Department of Environmental Quality

Re: **Summary of Bi-weekly Inspection of Lost Creek ISR LLC's Permit 788**

Wyoming Department of Environmental Quality (WDEQ)- Land Quality Division (LQD)
Inspection Memorandum

Photo Addendum to accompany the September 4, 2013 Inspection of Lost Creek ISR's Permit 788

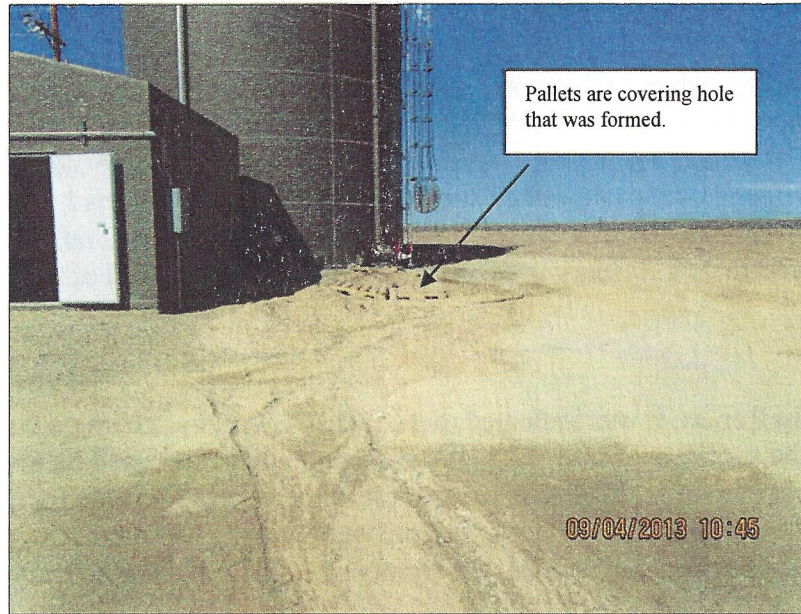
The water that overflowed out of the storage tank caused some piping immediately adjacent to the storage tank and some rilling about 30 feet east of the storage tank (see attached photo addendum) resulting in a trench with the following approximate dimensions: 2' x 2' x 5'. The water then flowed downhill another 10 feet to an earthen drainage channel, then under the Plant Site's northeast entrance route (which is the alternate/emergency access route to the Plant Site) via a culvert, and then flowed another 50 feet (still within the drainage channel) before seeping into the ground. No erosion occurred in the drainage channel itself. The erosion was limited to the piping (hole) next to the tank and the rills about 30 feet east of the tank.

The attached photo addendum depicts the areas that incurred erosion due to this overflow. LCI is encouraged to reconsider the drainage needs around the water storage tank. If sumps or a lined drainage channel are needed to accommodate future mishaps with overfilling the tank, LCI staff should proceed with their construction. Any alterations made to this area to address the erosion that occurred as a result of this overflowing event can be addressed in the Annual Report.

Photo Number 1: This depicts the fire-suppression water storage tank in the northwest corner of the plant site. The area covered with pallets is where some piping occurred (forming a 3' deep hole) where water pooled after overflowing out of the hose that was used to fill the storage tank from its associated water supply well.

Photo Number 6: This is a closer view of the backfilled mud pit (with subsidence) for the water supply well at the southwest corner of the DDW-4 site.

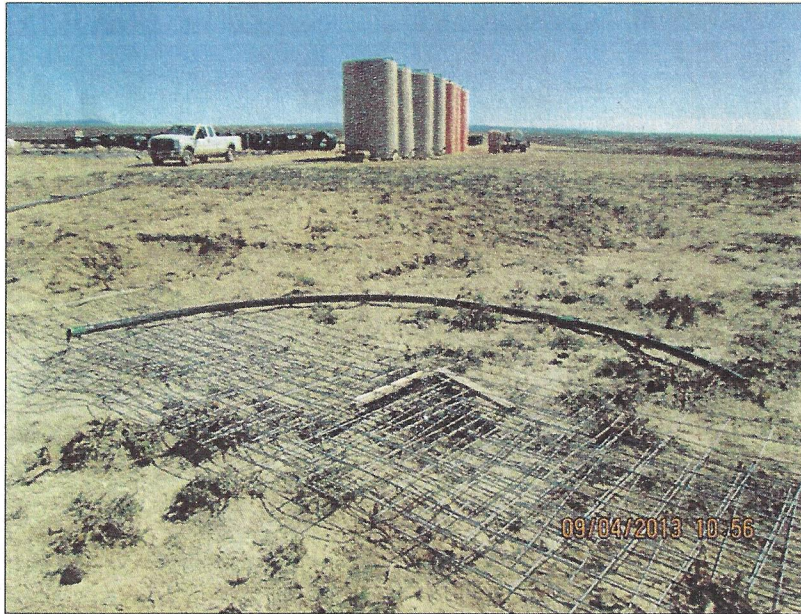
(backfilled) mud pit is showing signs of subsidence. The subsidence will need to be repaired prior to the application of seed this fall.

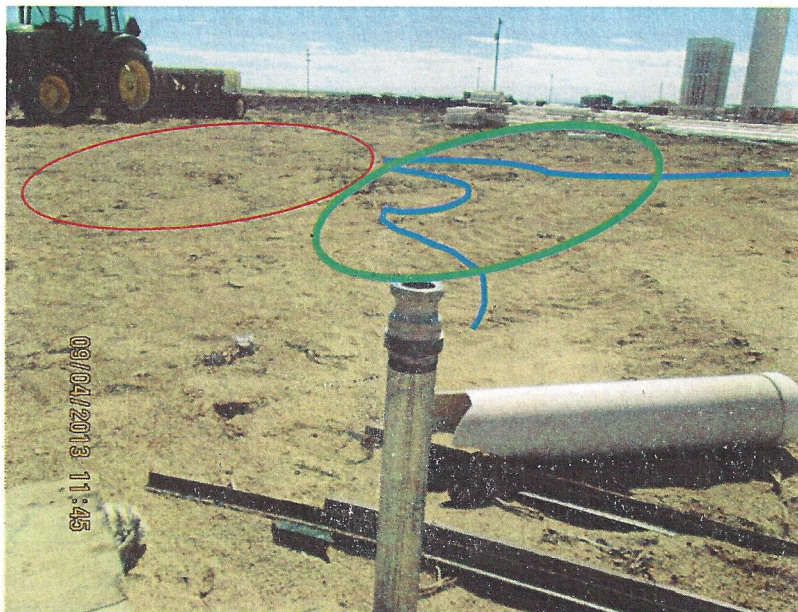
Photo Number 7: This depicts the well head for M118. It is at the west edge of the "field laydown area" just north of MU1, which is being cleared for fall reclamation. The area indicated by the circles are places where sage brush was trampled. The blue line indicates the approximate flow path of purge water from biweekly well sampling events. The area encircled in red does not receive any of the purge water (see Photo Number 9 on the following page). However, the area encircled in green does receive purge water. The sage in this area is showing signs of life (as depicted in Photos 9 and 10 on the following pages).
